## **DC/17/2524: The Paddock, Micklepage, Nuthurst**

Comparison of the retrospective planning application, DC/17/2524, as amended on 11 December 2017, with the approved plans under DC/15/2493. There are 46 changes, some of which are major (see detailed analysis below), and these do not constitute “minor amendments”. It should be noted that all of these changes have been carried out by Greenplan Designer Homes without first obtaining planning permission.

### 1. Site Plan

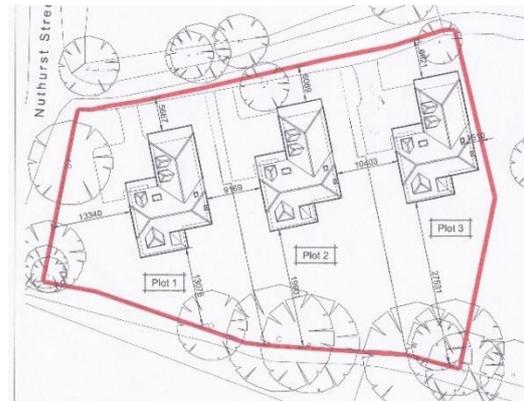
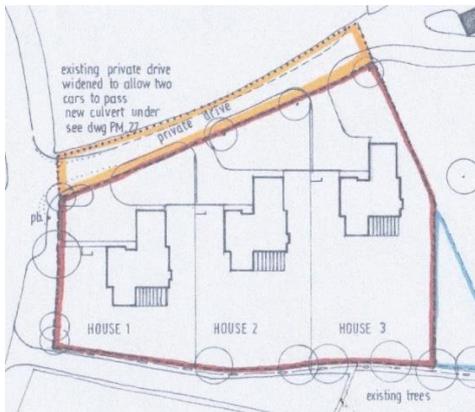
- All 3 houses moved forward in plot, houses 2 and 3 by a significant amount
- Plots sizes have changed, house 1 much larger, house 3 smaller
- Orientation of houses changed: now at right angles to access road instead of at an angle
- Houses now in a straight line, parallel to access road, instead of being staggered
- Drainage ditch at front of plots has been filled in contrary to policy 7iii of the Neighbourhood Plan which required the access drives to bridge the ditch

### 2.1 Front/North

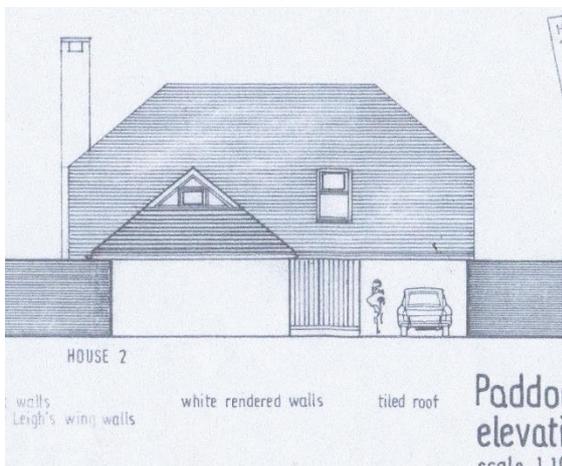
- Three extra columns supporting new roof canopy over front of garage and single door into garage (left hand side)
- Single front door with small window, instead of double door.
- New window and two columns supporting new roof canopy over front door (right hand side)

- New roof window (left hand side)
- Much larger and higher by 1.4 m roof triangle over garage (left hand side). This is of particular concern given the likelihood of conversion of this room from a “roof room for storage” to a bedroom with en-suite bathroom.
- New roof dormer on right hand side of triangular roof
- Changed window in roof (right hand side)
- New dormer window in roof (right hand side)

## 2.2 Rear/South

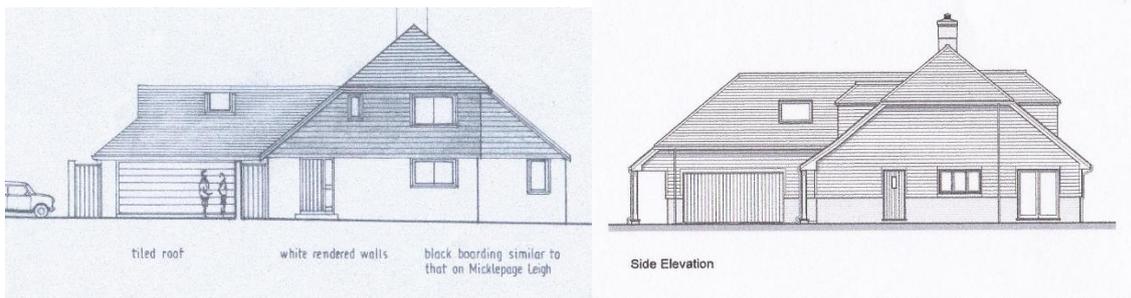
- New three pane window instead of two pane (left hand side)
- New two pane window (middle)
- New patio doors with side windows on left hand side instead of four fold patio doors in middle

- Extended roof over left hand and new middle windows
- New dormer window (left hand side). Inserting frosted glass instead of plain glass is unsatisfactory as it is unlikely to be permanent
- Two changed windows (middle and left hand side)

## 2.3 Side elevation/West

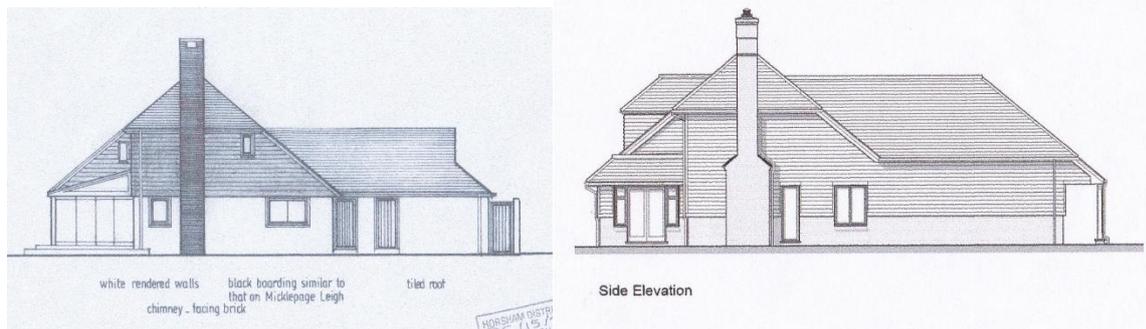
- Door removed (left hand side)
- Door removed (right hand side of garage)
- Door with inset window instead of door with adjacent window and moved to right
- Three paned window instead of two paned window
- Double patio doors instead of single window (right hand side)

- Changed and considerably raised roof line on left above garage to facilitate another bedroom with en-suite bathroom
- Position of single roof window changed (left hand side)
- Insertion of new dormer roof on left side of roof triangle
- Significant extension of, and significantly higher, roof on right hand side
- Amended plan has omitted two dormers above the garage that currently exist (see photo above).

## 2.5 Floor Plan

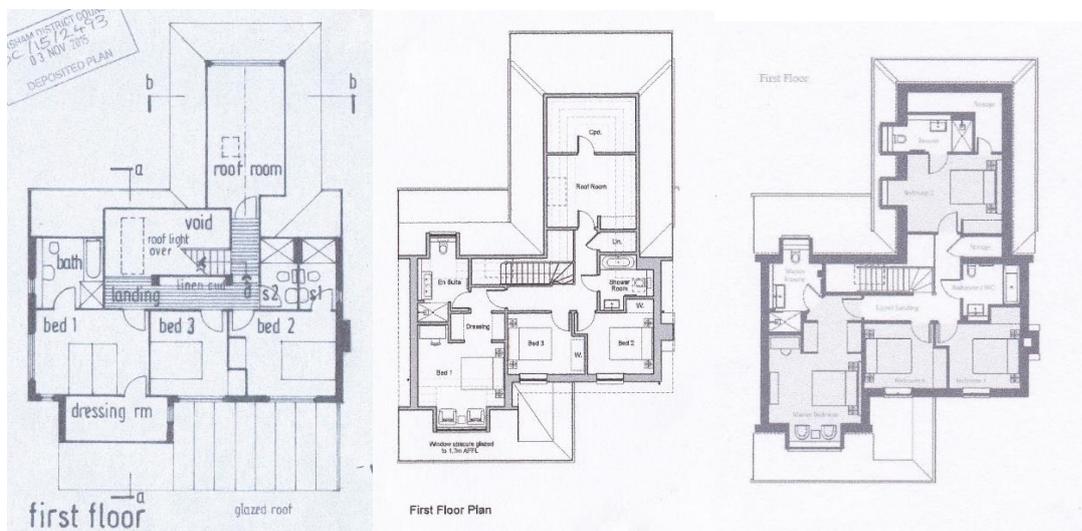
- Sun room and dining room are now breakfast room with dining facilities on right hand side
- Utility is now a downstairs toilet and shower
- Part of kitchen is now utility
- Plant room and study is now called a dining room (shown as bedroom 5 on Connells, Estate Agent's particulars)
- Ground floor area (footprint) increased by approximately 5m<sup>2</sup> by squaring off bottom left hand side and top right hand side.

- Roof room has been renamed “roof room and cupboard” (shown as bedroom 2 with en-suite bathroom on Connells Estate Agent's particulars). This is in order to blatantly reduce the number of bedrooms to 3 to “fit in” with the original planning permission. However with the increase in roof height and plumbing already installed for an en-suite, it is inevitable that this will once again become an en-suite bedroom. Note that the approved room had a strip of only 90cm, 2m high making it an uninhabitable room, whereas the amended plan has a strip of 2.5m, 2m high clearly making it a habitable room.,
- En-suite (s1) and toilet (s2) have become family bathroom plus toilet
- Glazed roof over ex sunroom and porch has been removed
